# Access Compliance Report

## Public Rights-of-Way

Intersection ID: 54218	Main Street: GOLF_LINKS_DR	Cross Street: SANDY_ROCK_PL	Location: NW
ADA ID: 72E424C70FE6	Ramp Type: Perp	Initial Pass/Fail: Fail	Overall Compliance: No
Severity Score: 12.5			
Codes/Mitigation Info/Possible Solution		Field Measurements/Component Compliance

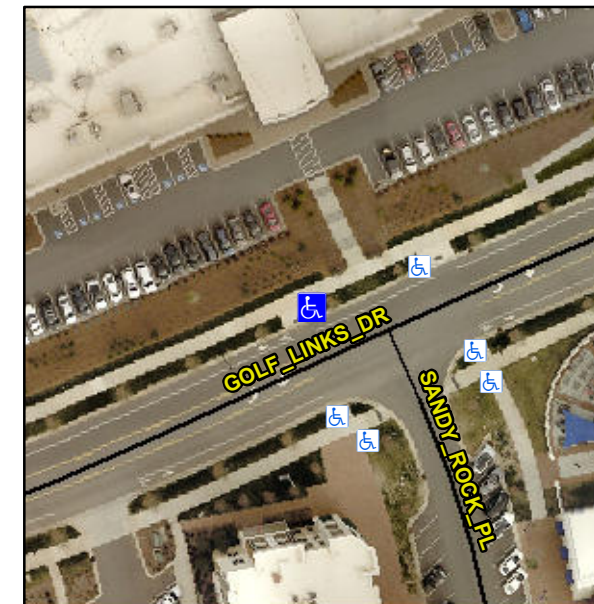
**Not Found, R304.2.2**

Compliance	Description	Data	Compliance	Description	Data
N/A	Ramp Length (in)	95.5	No	Ramp Slope (%)	9.1
Yes	Ramp Width (in)	60.0	Yes	Ramp XSlope (%)	1.7
N/A	Flare Type LT	N/A	N/A	Flare Type RT	N/A
N/A	Flare Slope LT (%)	N/A	N/A	Flare Slope RT (%)	N/A
N/A	Flare Traversable LT?	N/A	N/A	Flare Traversable RT?	N/A
N/A	Landing Length (in)	N/A	N/A	DWS Provided?	N/A
N/A	Landing Width (in)	N/A	N/A	DWS Contrast?	N/A
N/A	Landing Slope (%)	N/A	N/A	DWS Length (in)	N/A
N/A	Landing X Slope (%)	N/A	N/A	DWS Full Width?	N/A
N/A	Landing Curb? (Y/N)	N/A	N/A	DWS Offset (in)	N/A
N/A	Shared Landing?	N/A			
N/A	Gutter Ponding?	N/A	N/A	Gutter Slope (%)	N/A
N/A	Gutter Lip Ht (in)	N/A	N/A	Gutter X Slope (%)	N/A
N/A	Painted X Walk1?	No	N/A	Painted X Walk2?	N/A
	X Walk 1 Direction	To S		X Walk 2 Direction	N/A
N/A	X Walk 1 Width (in)	N/A	N/A	X Walk 2 Width (in)	N/A
	X Walk 1 Slope (%)	4.2		X Walk 2 Slope (%)	N/A
	X Walk 1 X Slope (%)	1.2		X Walk 2 X Slope (%)	N/A

**Remove & Replace Entire Ramp.**
